ADDENDUM NO. 1

ISSUE DATE: September 7, 2023

PROJECT: City of Slaton
Senior Citizen Center

NO.	REVISION	DATE	9/7/2023	PROJECT #	SCALE	21602	SHEET
	ADDENDUM 1						
				BAR IS ONE INCH IN LENGTH ON ORIGINAL DRAWING. CHECK SCALE AND ADJUST ACCORDINGLY.			
				S2.0

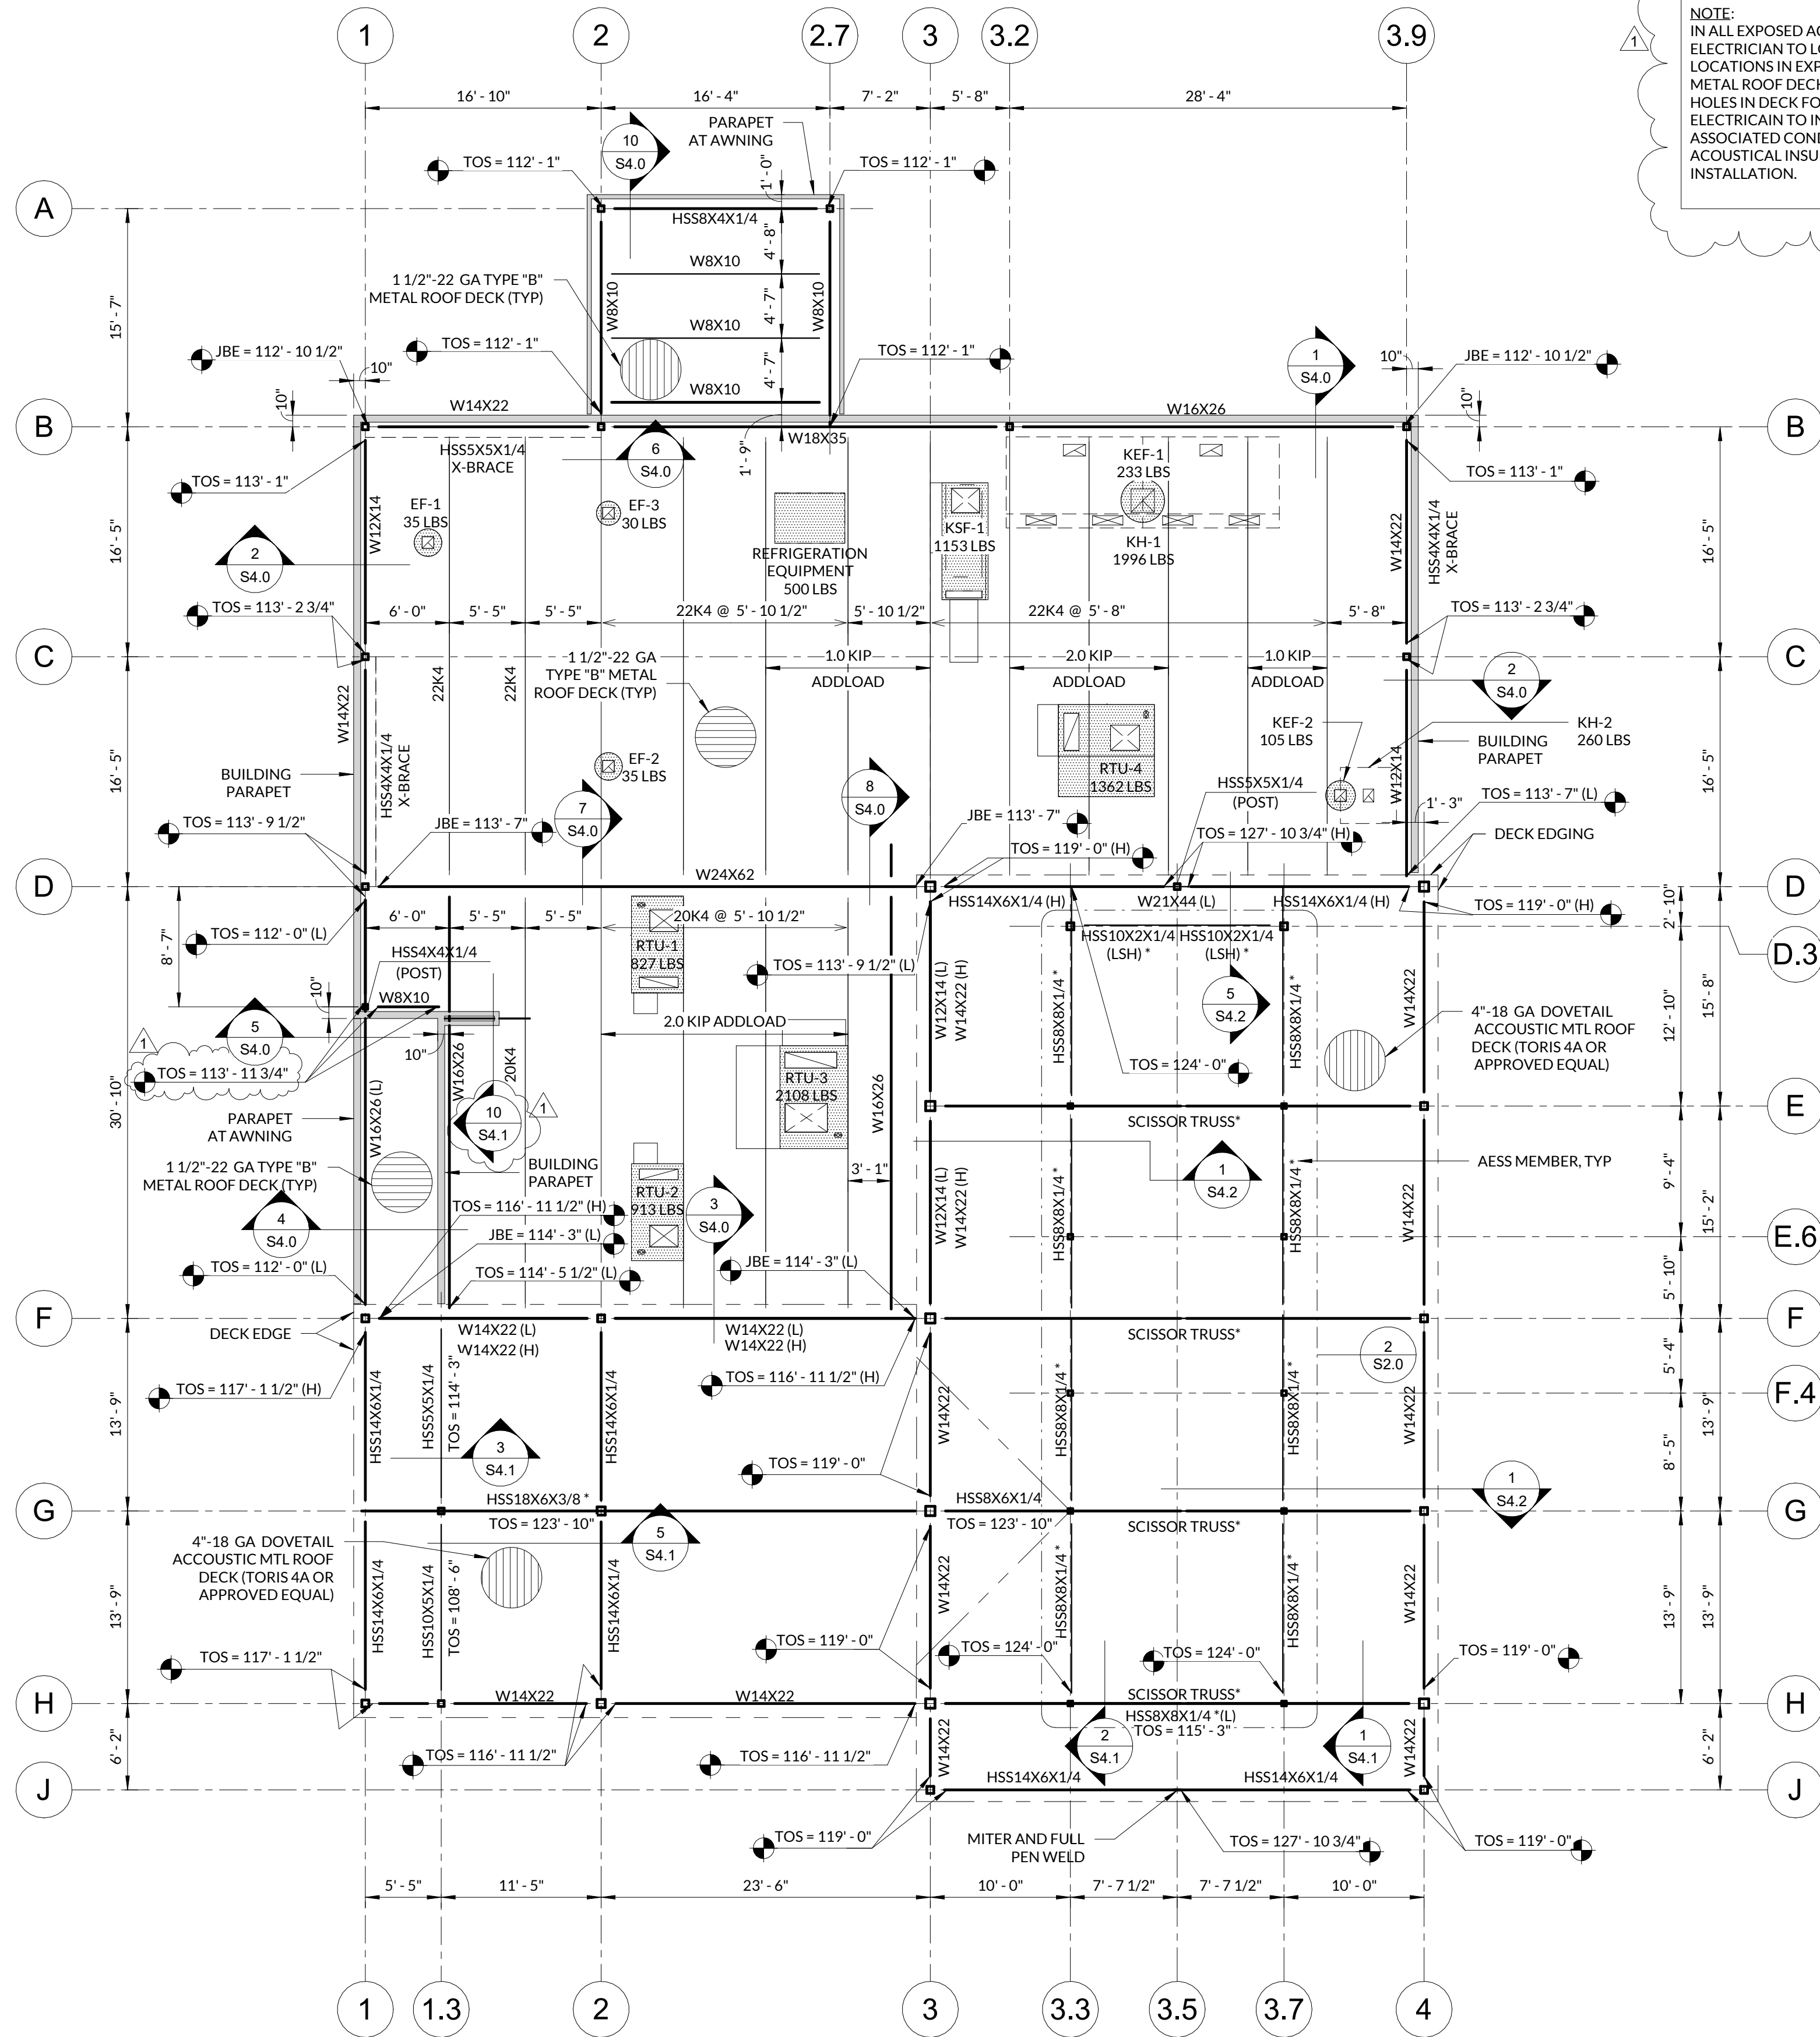
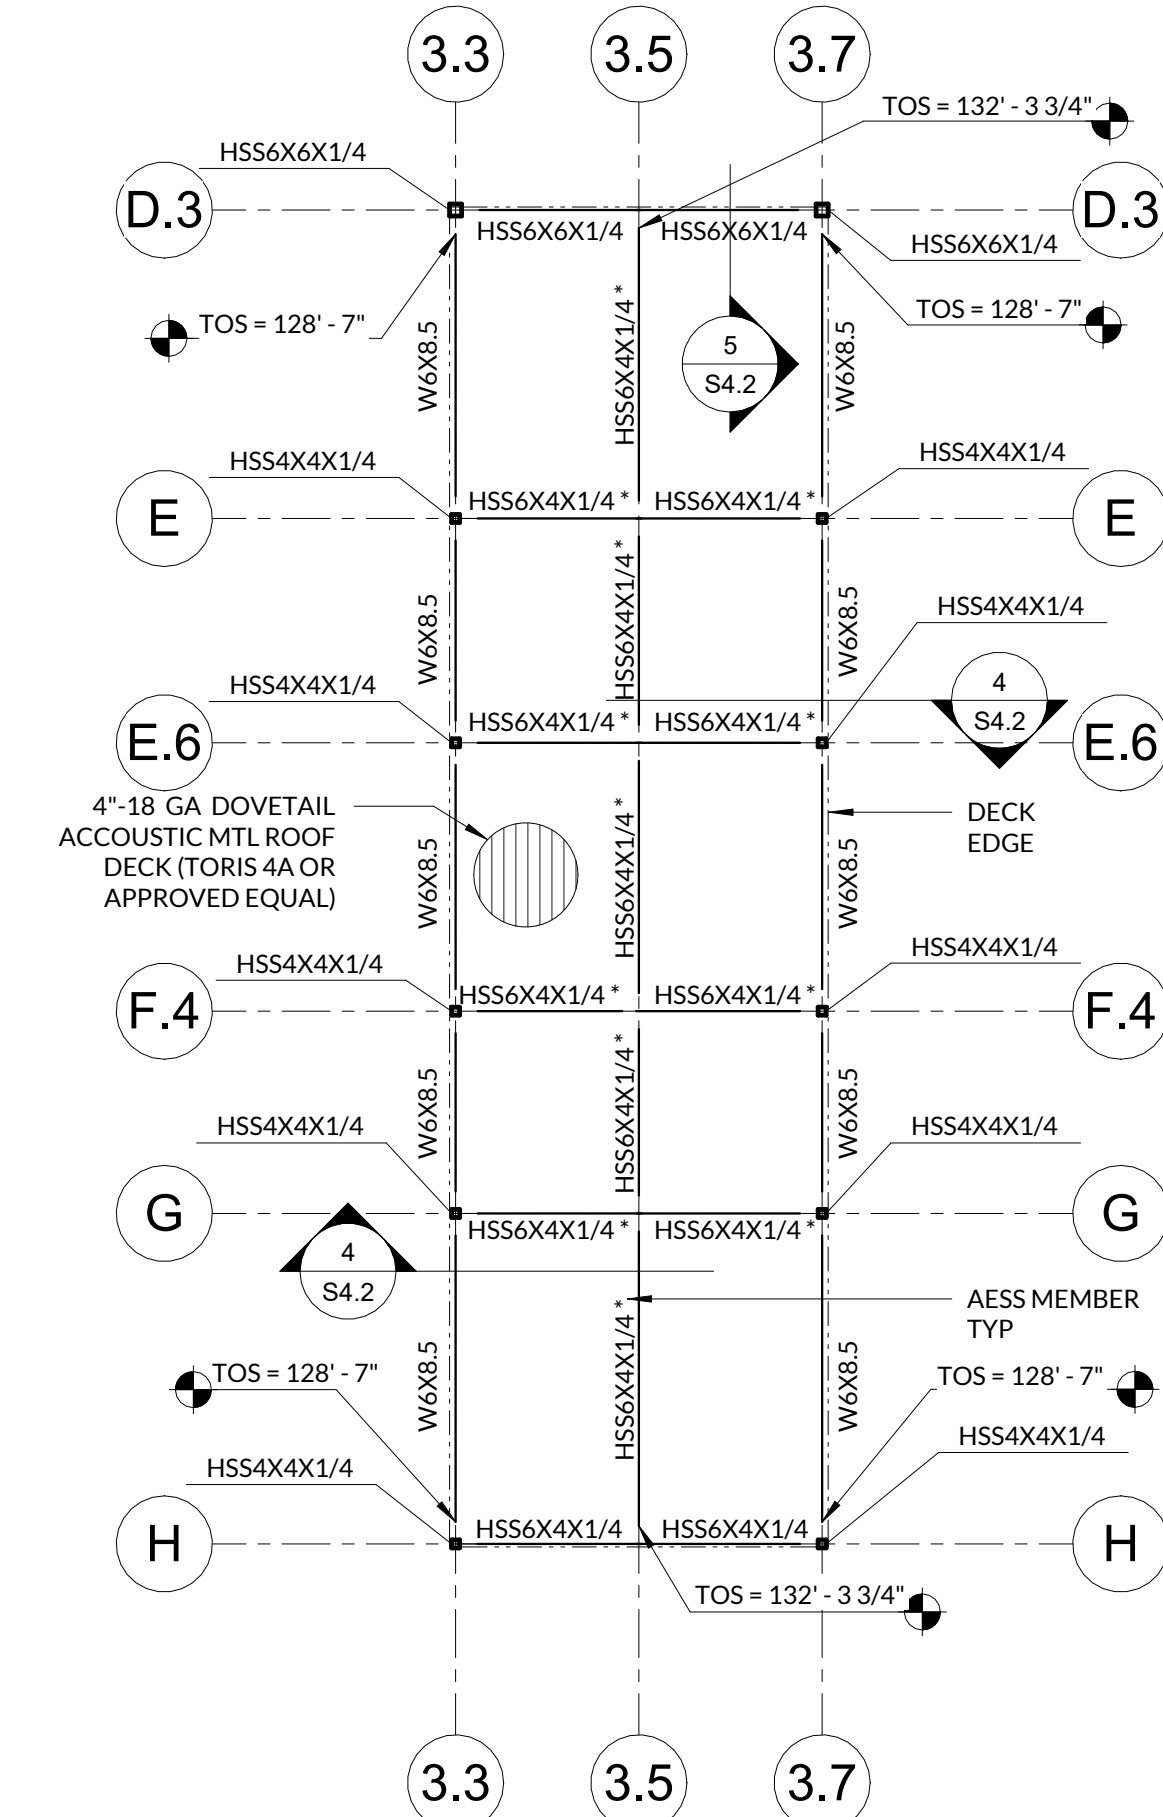
- Item #D3** **Sheet S2.0** - REPLACE sheet with attached S2.0 dated 09-07-2023. ADDED section cuts for new framing detail, added note for electrical J-box coordination, and MODIFIED beam elevation between grid lines D and F.

2 TYP DIAMOND POUR DETAIL

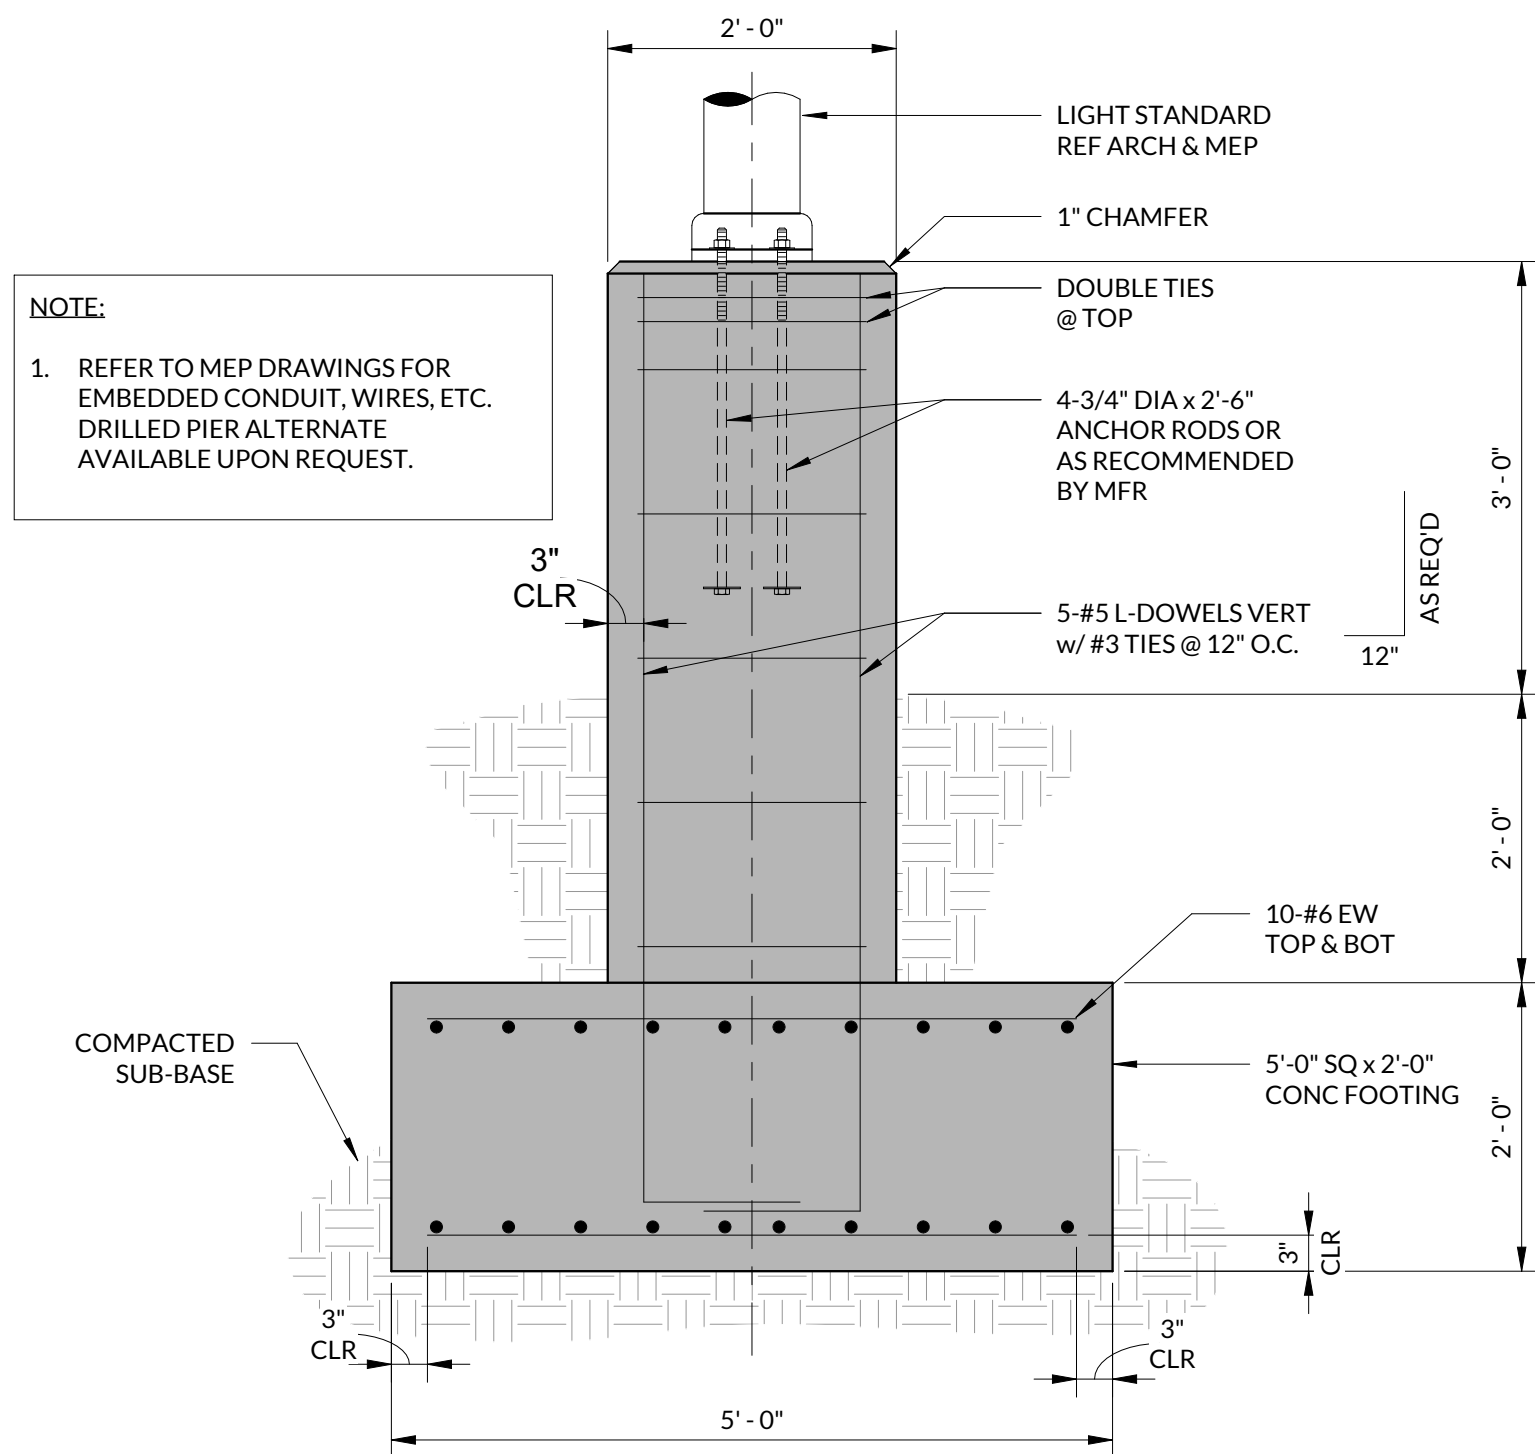
- Item #D4** **Sheet S3.0** - REPLACE sheet with attached S3.0 dated 09-07-2023. MODIFIED detail 2.
- Item #D5** **Sheet S3.1** - REPLACE sheet with attached S3.1 dated 09-07-2023. ADDED new details referenced from S1.0.

3 TYPICAL ROOF STEP DETAIL
SCALE: 3/4" = 1'-0"

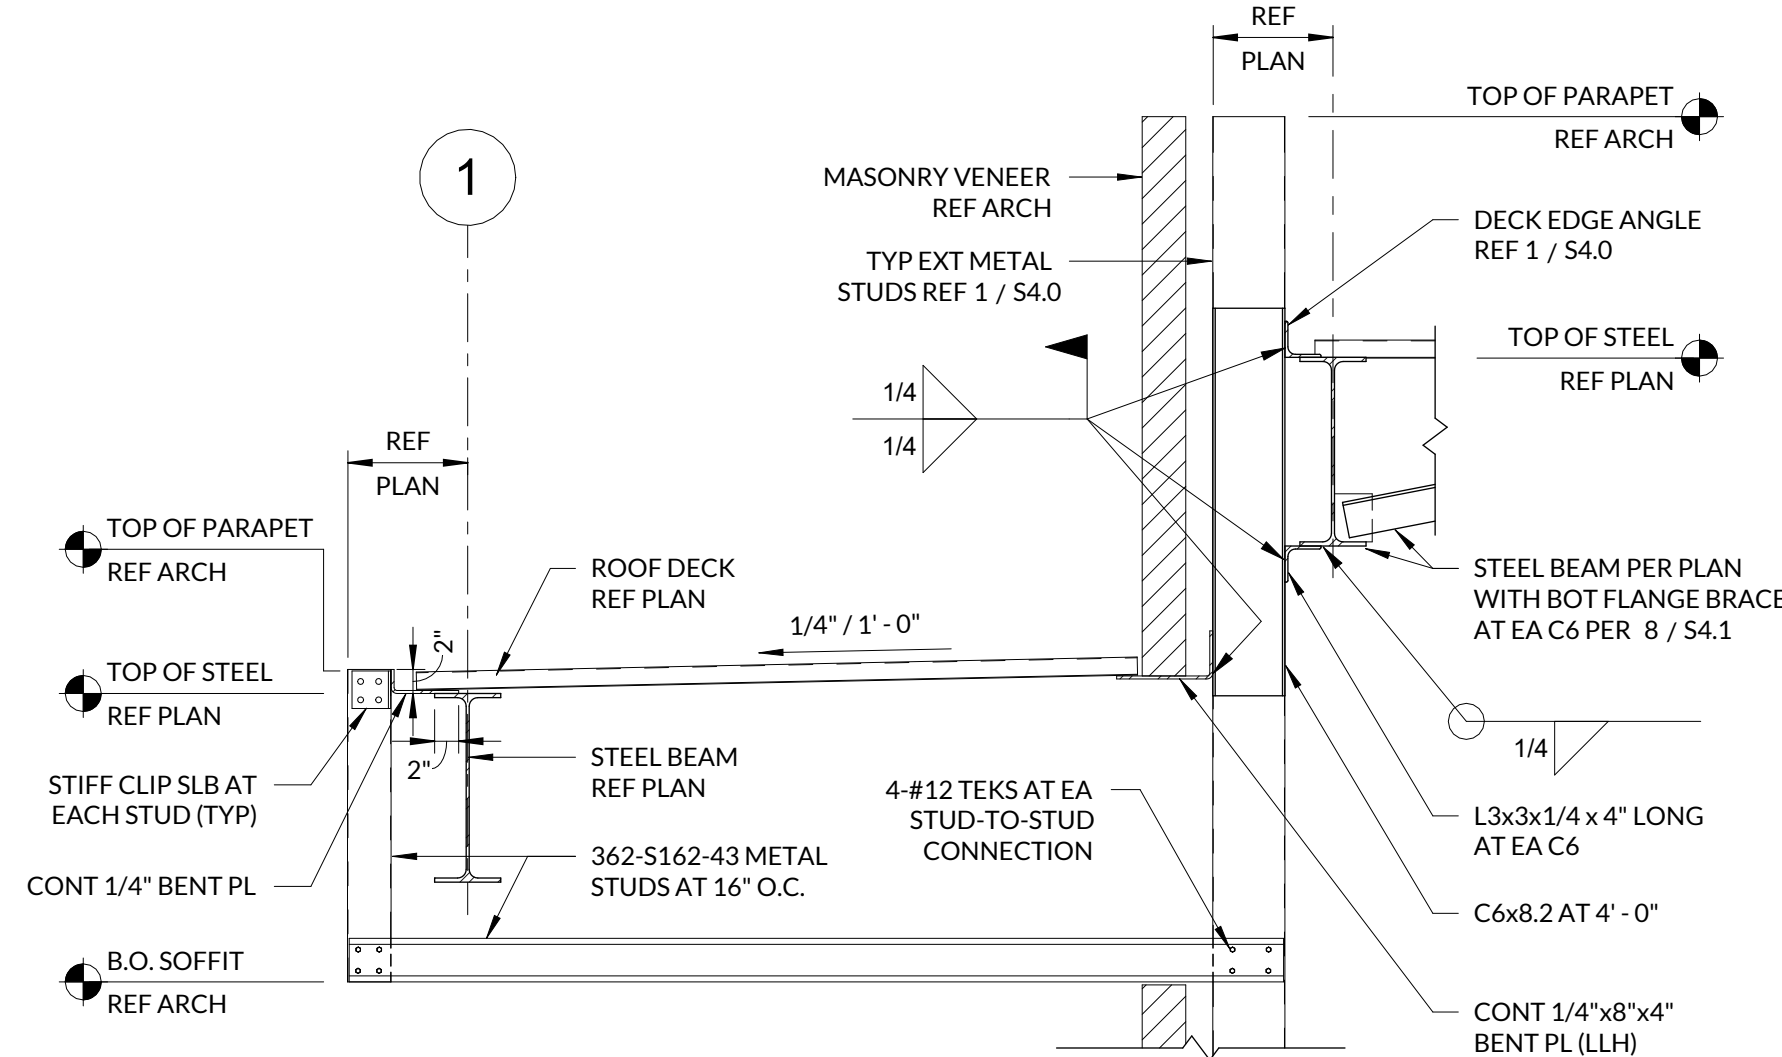
- Item #D6** **Sheet S4.0** - REPLACE sheet with attached S4.0 dated 09-07-2023. MODIFIED detail 3.
- Item #D7** **Sheet S4.1** - REPLACE sheet with attached S4.1 dated 09-07-2023. MODIFIED detail 8 and ADDED new detail 10 as referenced from S2.0.
